REMARKS

METHODS AND SYSTEMS FOR PROCESSING MICROFLUIDIC SAMPLES
OF PARTICLE CONTAINING FLUIDS

Gene Parunak et al.
10/014,520/ 19662-026001
ANNOTATED SHEET

Fig. 1

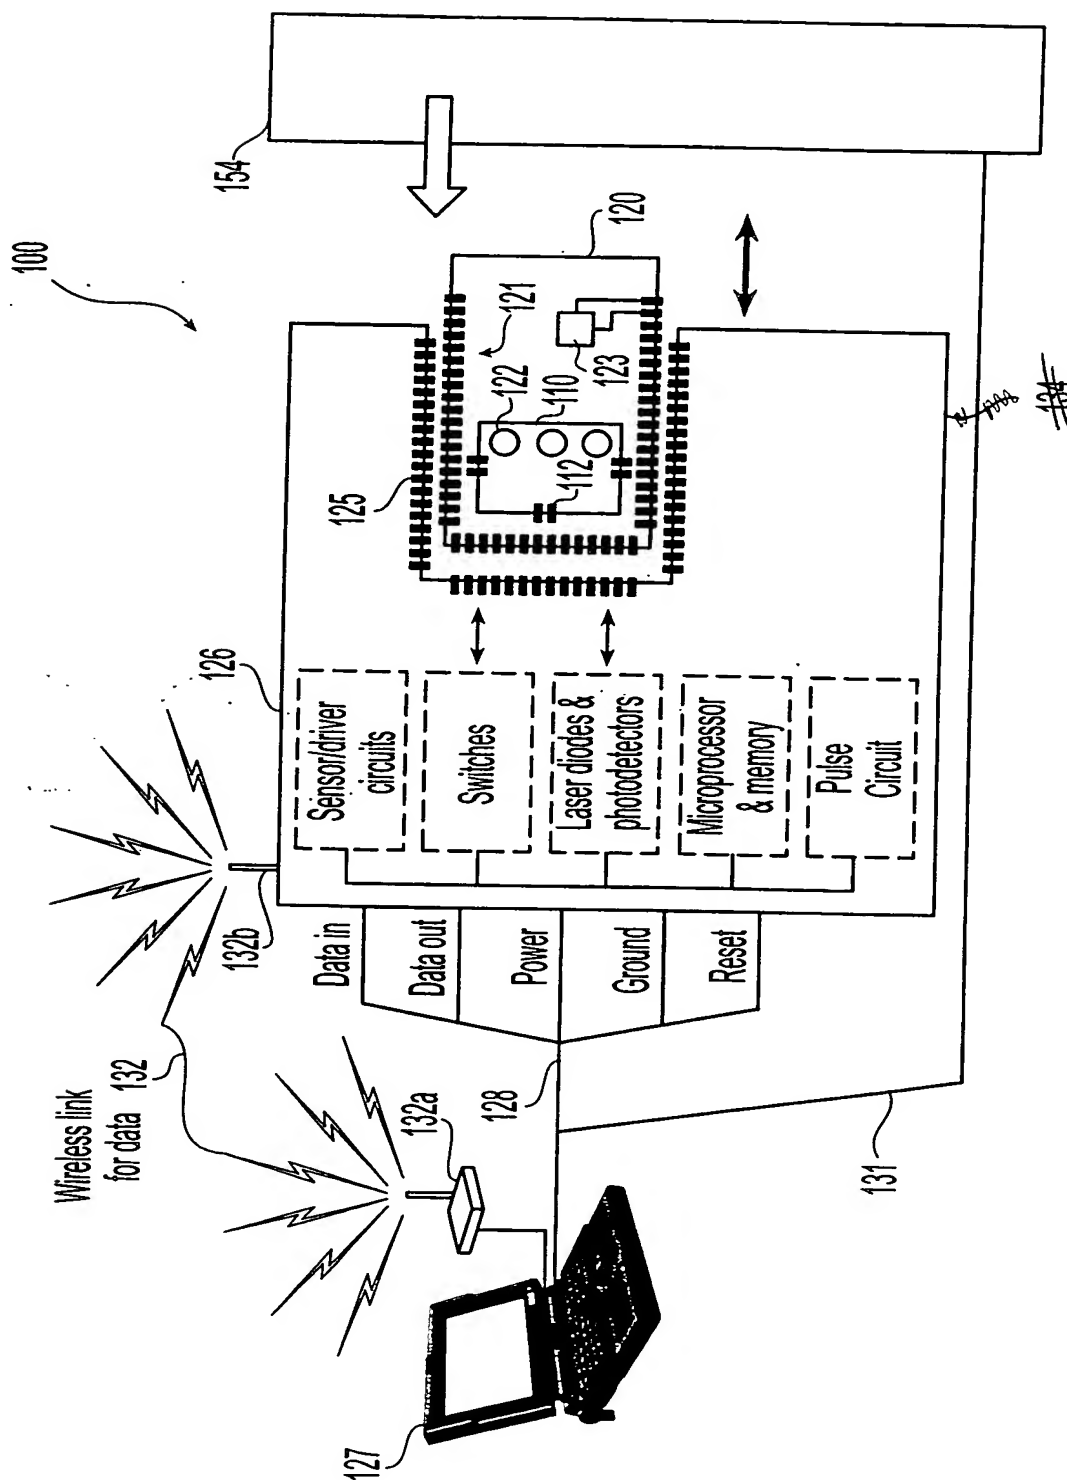
FIG. 1 is amended to delete reference numeral 134. Applicants respectfully point out that, as would be clear from the accompanying portion of the specification, the correct reference numeral 134 refers to a different element, as shown in FIG. 2.

Fig. 2

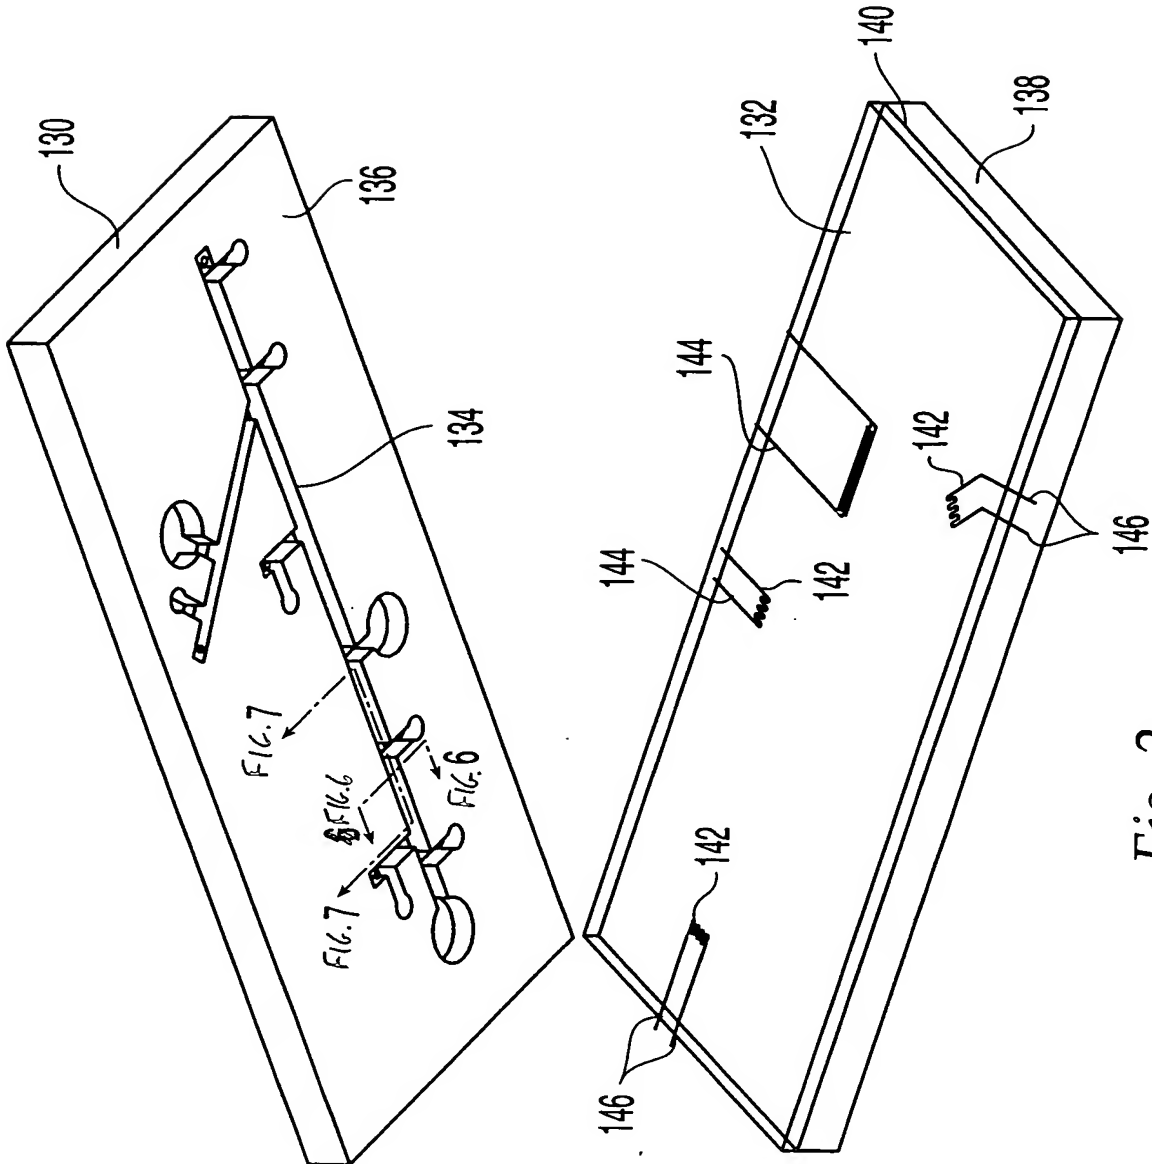
FIGs. 2, 4, 8a, and 9a are amended to insert references to corresponding figures wherein arrows are shown to indicate a cross sectional view.

Fig. 8a

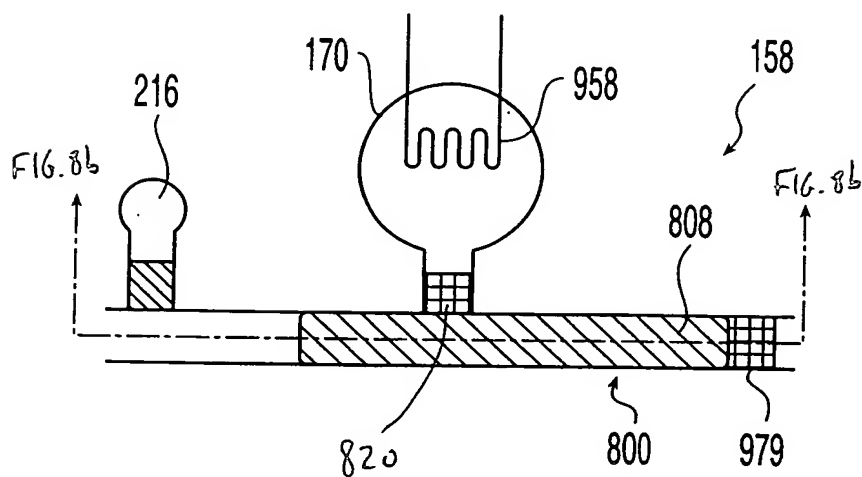
FIGs. 8a and 8b have been amended to insert reference numeral 820, as found in the accompanying description in the specification as filed.

Fig. 9a

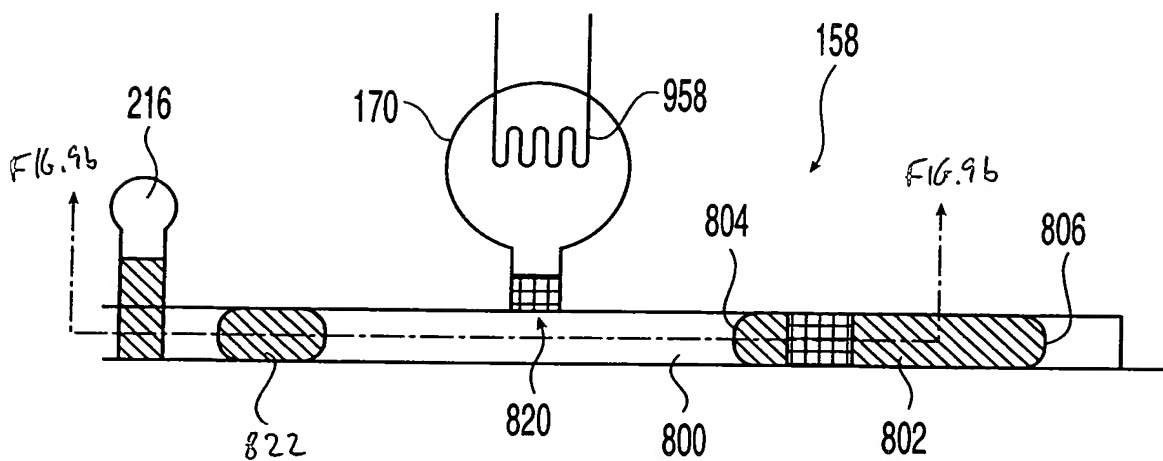
FIGs. 9a and 9b have been amended to insert reference numeral 822, as found in the accompanying description in the specification as filed.

Fig. 11a

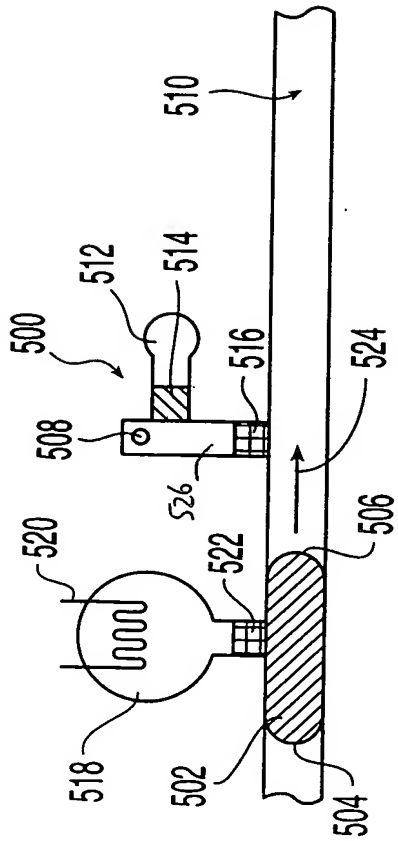
FIGs. 11a – 11c have been amended to insert reference numeral 526, and FIG. 11b has been amended to insert reference numeral 504, as found in the accompanying description in the specification as filed.

Fig. 12a

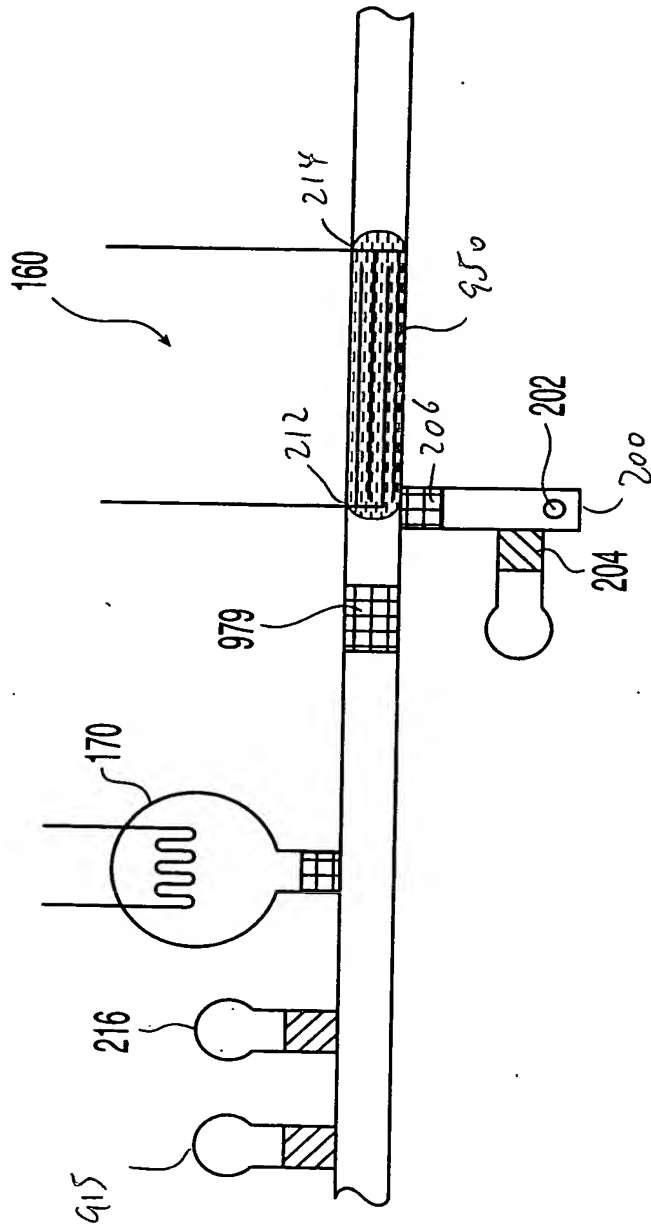
FIGs. 12a and 12b have been amended to insert various reference numerals, including 200, 206, 212, 214, 915, and 950. The positioning of such reference numerals is based on other drawings as filed and the accompanying description found in the specification as filed.

Fig. 15c

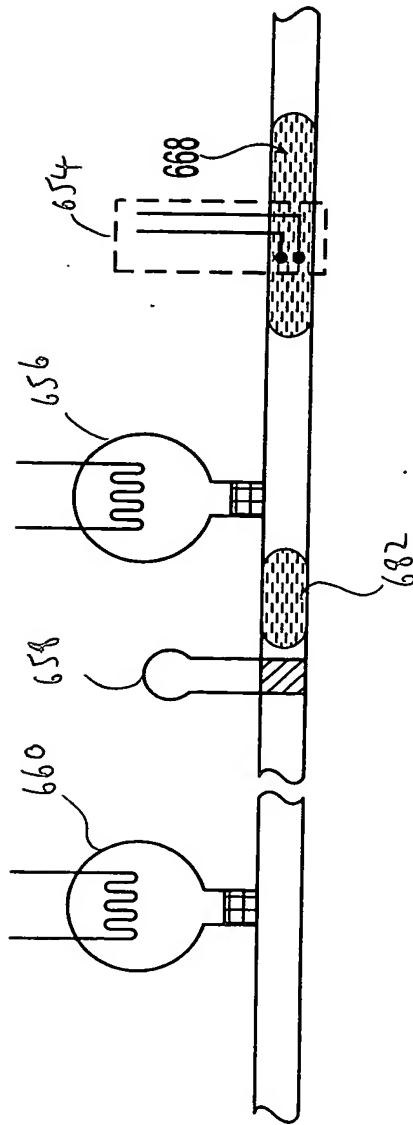
FIG. 15c has been amended to insert various reference numerals, including 654, 656, 658, 660, and 682. The positioning of such reference numerals is based on other drawings as filed (in particular FIGs. 15a and 15b) and the accompanying description found in the specification as filed.
